## "OOPS, WE GOOFED"

Vol 6, Page 32, and Vol 7, Page 63; Thumbwheel 200 Channel Update. Thumbwheel switches are BCD type. Also, the switch marked "Thousands", should be connected as follows:

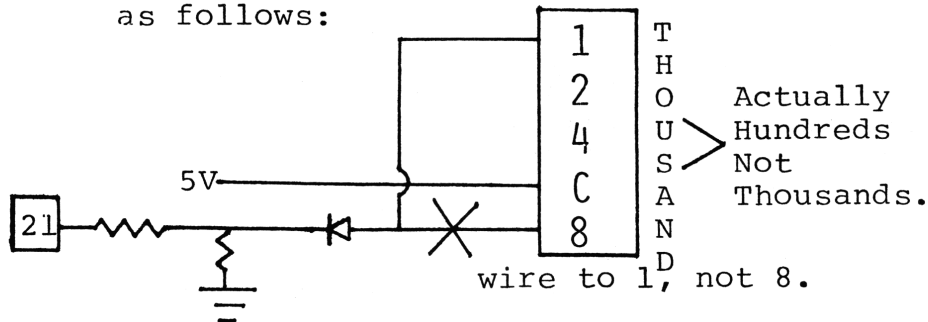
Also, the method of channel entry is in a code from 000-199 as shown on page 34 of Vol 6. You can't dial in "785" for 27.785. Rather, you must dial in "173" as per chart. The Tens, Hundreds, Thousands should really be Ones, Tens, Hundreds. Note: The thousands switch could be a simple SPST switch instead of the more expensive thumbwell type.
